Great Western Highway Upgrade Program – Little Hartley to Lithgow (West Section)

Submissions Report

Transport for NSW | April 2022

Prepared by Jacobs and Arcadis Joint Venture and Transport for NSW

Figure 3-1: Hartley Historic Site curtilage and land subject to revocation

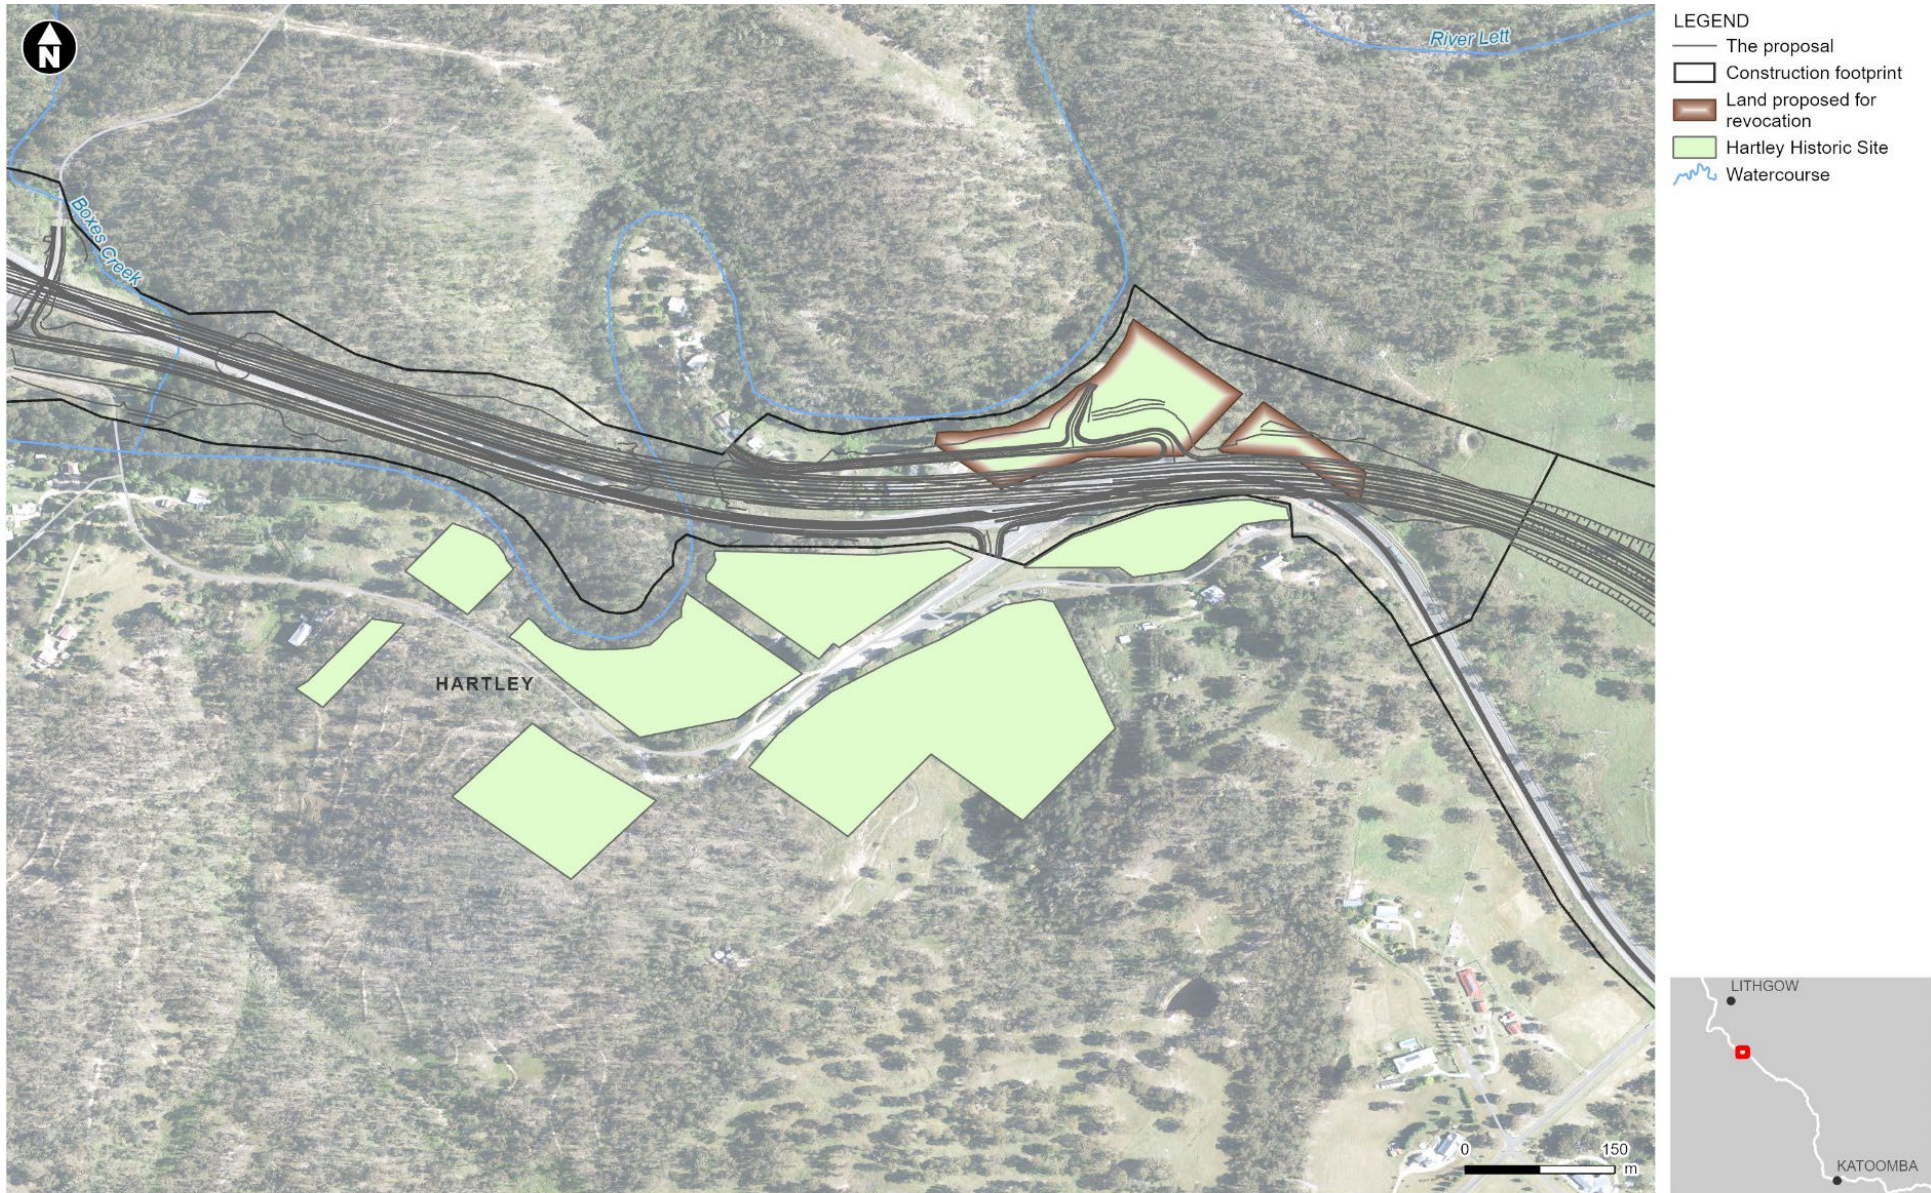
NPWS estate is not correctly identified in the REF. For instance, Figure 3-1 d (p. 25) appears to contain the following errors:

The mapping associated with the REF does not provide clarity on these concerns. For instance, Figure 3-3 b Proposal construction footprint (p. 48) shows a proposed construction footprint that appears to encroach onto the area of park not proposed for revocation (i.e. to the south of the existing highway alignment). It is not even clear from the mapping given the scale and quality of the maps exhibited whether the former Royal Hotel is excluded from the construction footprint. Similarly, Figure 1-3 Subject land (p. 26) in the Biodiversity Development Assessment Report (BDAR) (Appendix D of the REF) does not clearly exclude NPWS estate from “subject land”, which is defined in Section 1.2.1 of the BDAR (p. 25) to include the construction and operational footprints of the proposal.

It is acknowledged Figure 3-1d of the REF identifies the LEP heritage of the Hartley Historic Site however incorrectly states this land is NPWS land. The SHR curtilage that is NPWS land is identified and assessed in Figure 6-19, Section 6.5 and Appendix H of the REF. For clarity, the SHR curtilage is also shown in Figure 3-1 of this submissions report.

The land to be revoked is also identified in Figure 3-1 of this submissions report.

The proposal construction and operational footprint is shown in Figures 3-3 a to d of the REF. For clarity, Figure 3-1 in this submissions report shows the proposal and the construction footprint in relation to the SHR heritage curtilage of the Hartley Historic Site. Other than land proposed for revocation, no other land within this curtilage or other land reserved under the NPW Act would be directly impacted by the construction or operational footprints of the proposal.

Figure 3-1 provides more detailed mapping of the subject land / construction and operational footprint of the proposal at the Hartley Valley Historic Site, based on the mapping shown in Figure 3-3b of the REF and Figure 1-3 of the BDAR.

Figure 3-2: Utilities in the vicinity of the Hartley Historic Site

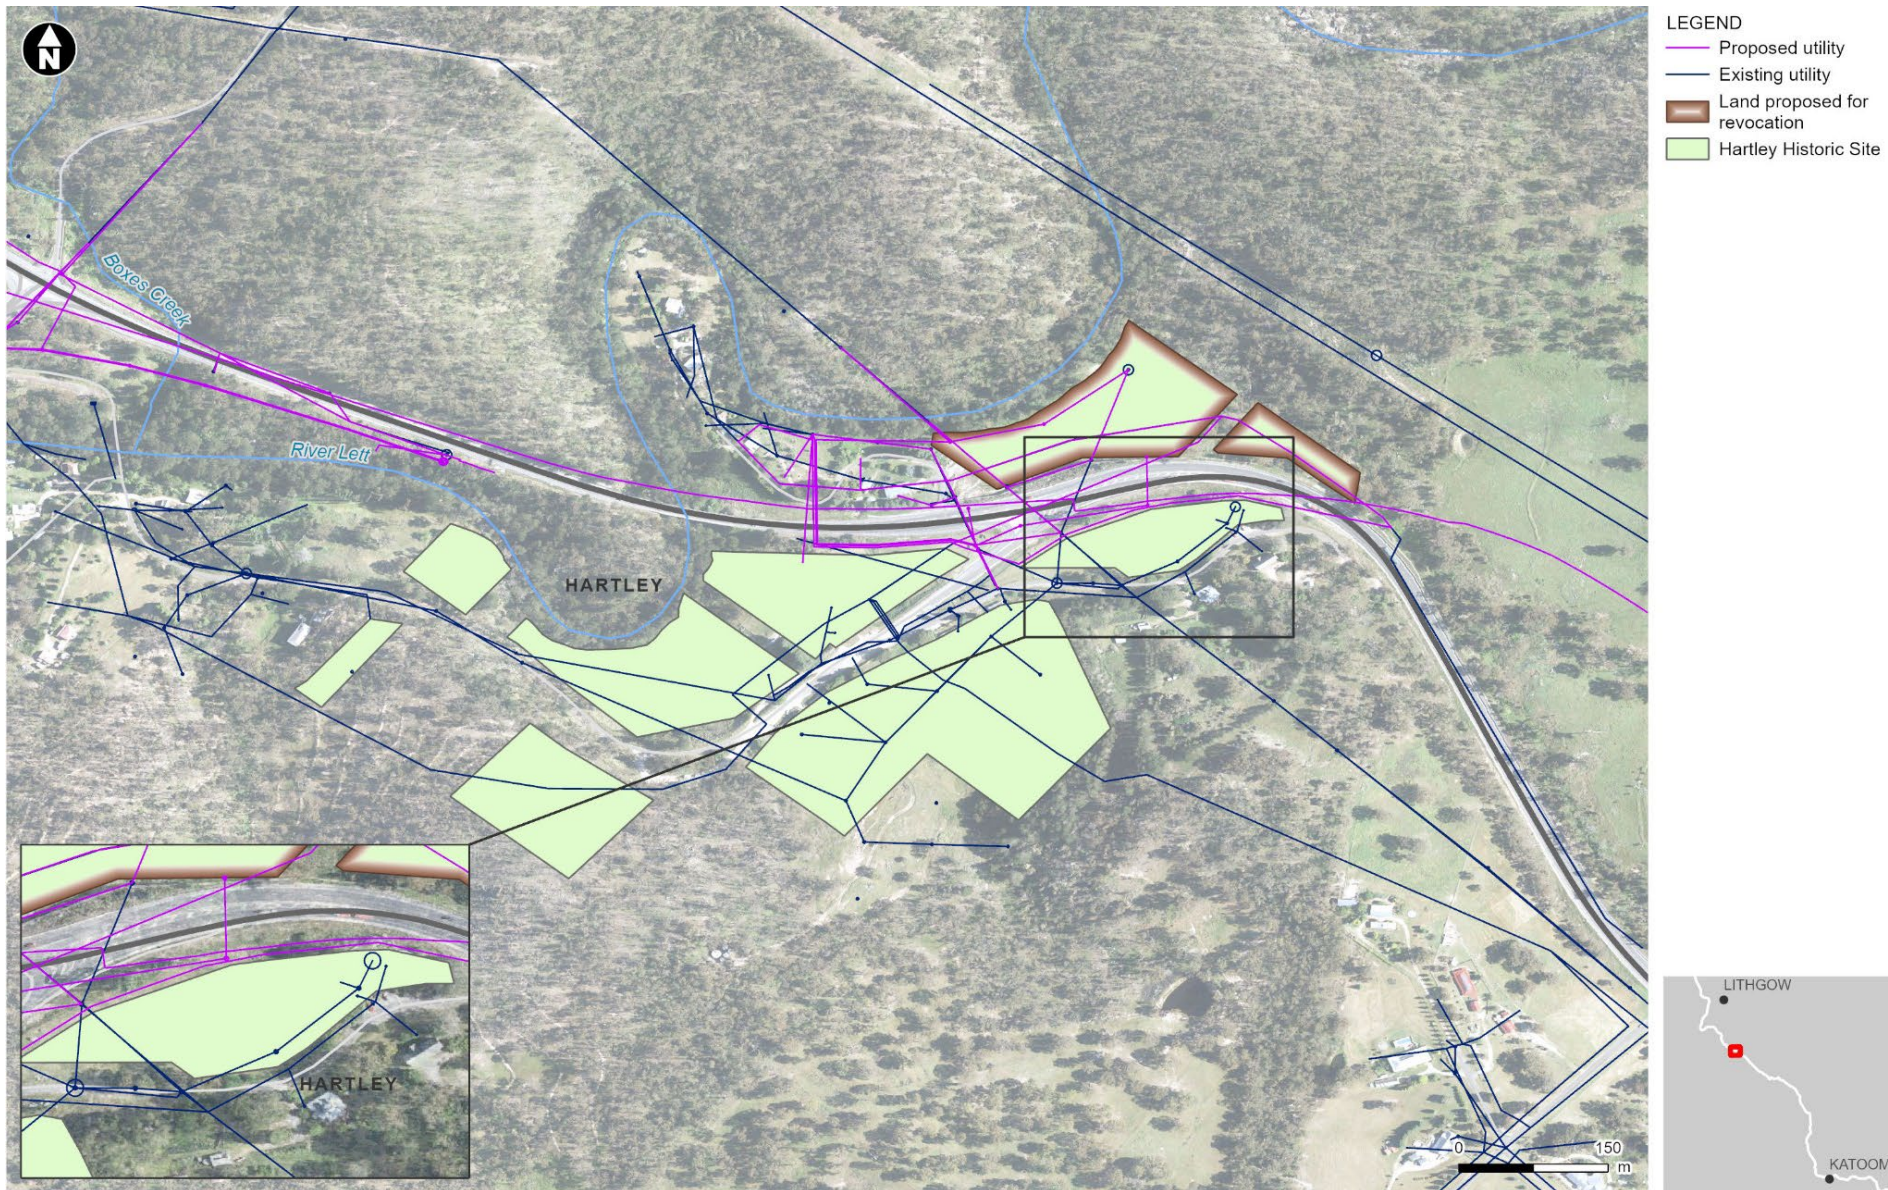
The existing and proposed utilities mapping (Figure 3-4 c Existing and proposed utilities, p. 70) is also unclear. It appears to depict significant infrastructure traversing Hartley Historic Site south of the current highway alignment however given the map quality it cannot be determined whether the mapped utilities are existing (retained) or proposed.

The existing utilities within the Hartley Historic Site to the south of the current highway alignment would not be impacted. Any utilities adjustments would be carried out within the construction footprint only, as shown with greater clarity in Figure 3-2.

Figure 3-3 Vibration impacts at the Hartley Historic Site

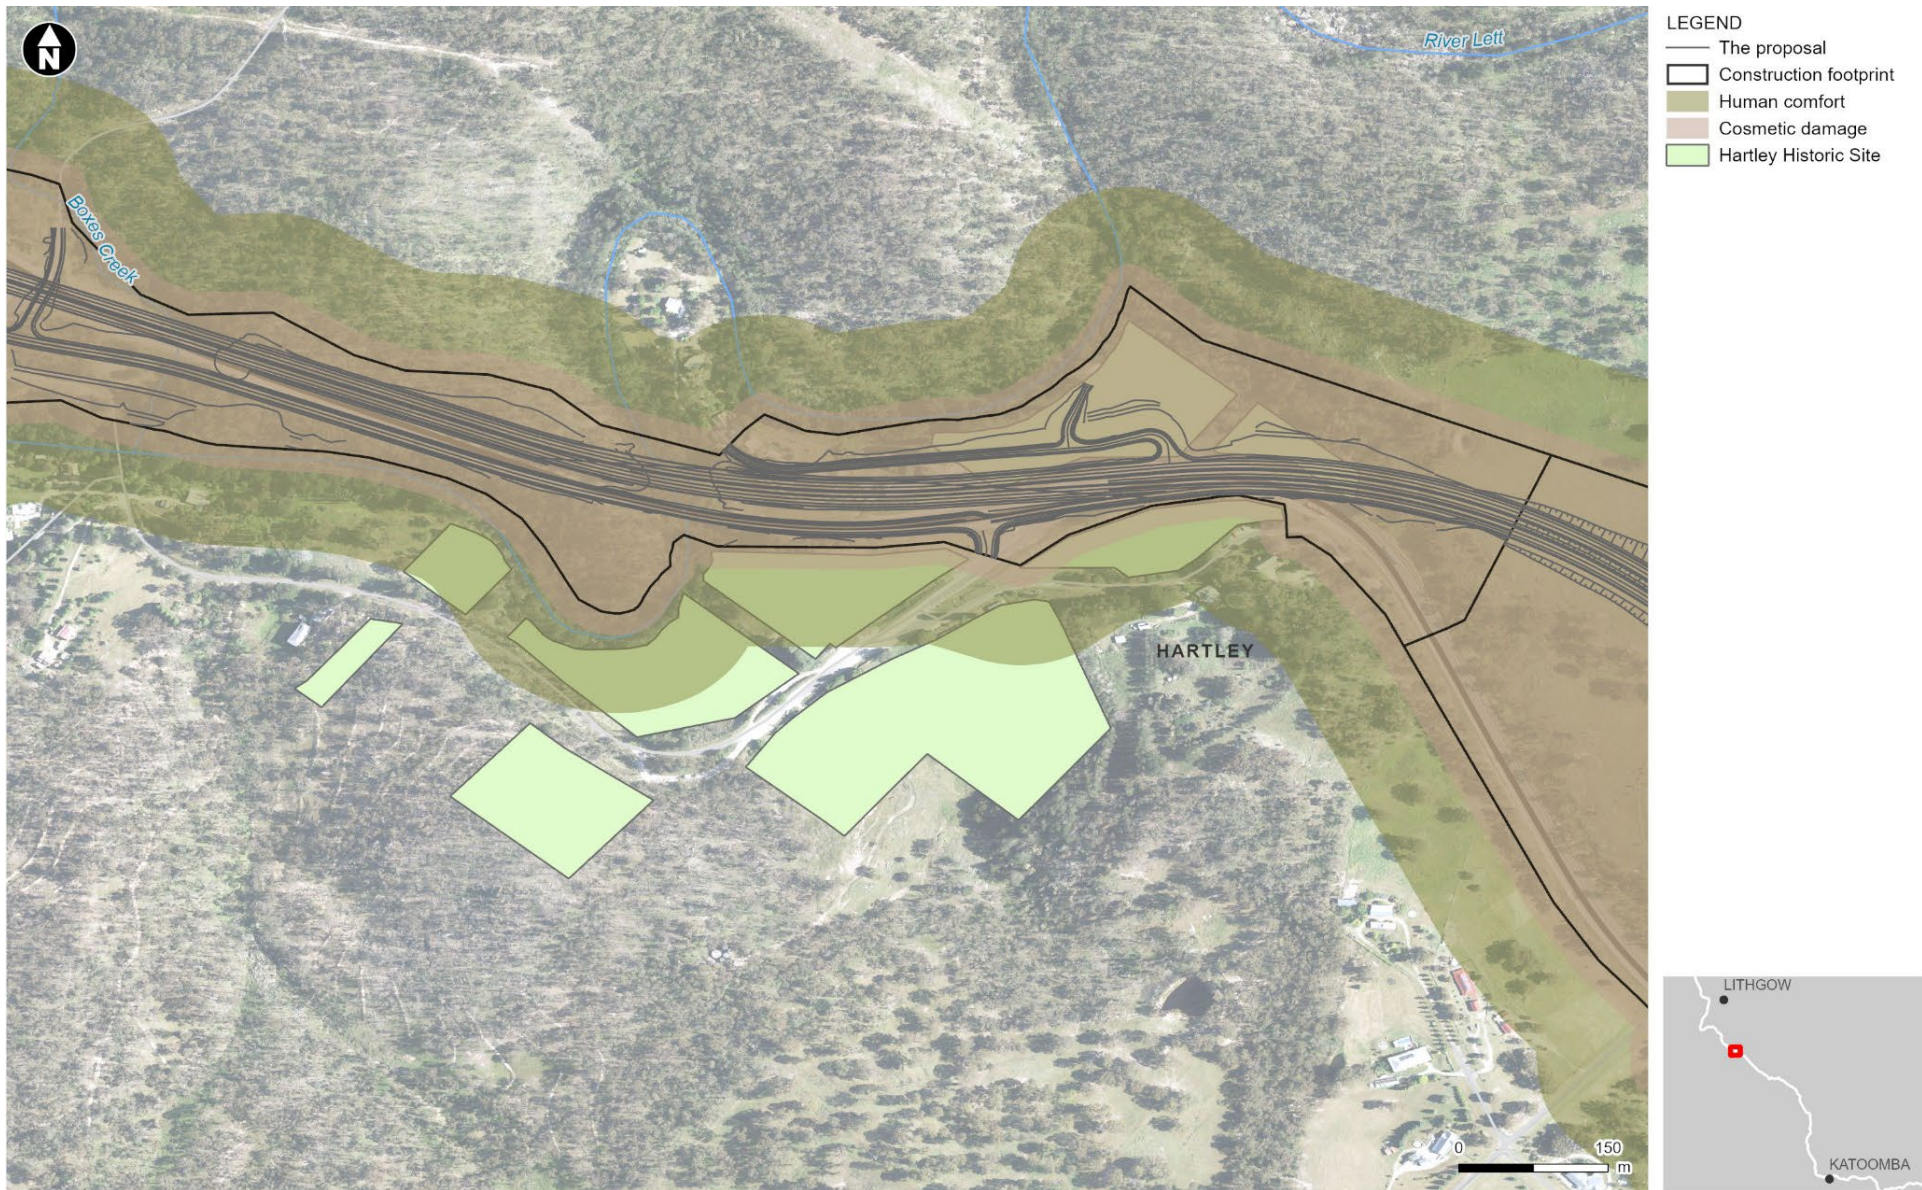
Concerningly, Figure 6-9 (Construction vibration assessment – Little Hartley to River Lett and Coxs River Road, p. 210) appears to show both road infrastructure and the cosmetic damage zone encroaching into the area of Hartley Historic Site south of the current highway alignment. Impacts to the historic site should be firstly avoided and, if not possible to avoid, mitigated. The REF does not demonstrate that this process has been followed given the cosmetic damage zone appears to encroach NPWS estate.

All proposed works would occur within the proposal construction footprint and would not directly impact the area of Hartley Historic Site south of the current highway alignment, as shown in Figure 3-1. As discussed in Section 6.3.3 of the REF, potential impacts during vibration intensive work have been assessed using the CVNG minimum working distances for cosmetic damage and human response. There are some areas of the Hartley Historic Site that are within the minimum working distances for cosmetic damage and mitigation will be required to be considered. Figure 3-3 provides more detail of the predicted vibration impacts on the Hartley Historic Site. Construction equipment that may cause vibration impacts would not occur on the boarder of the construction footprint, therefore serious impacts aren't expected.
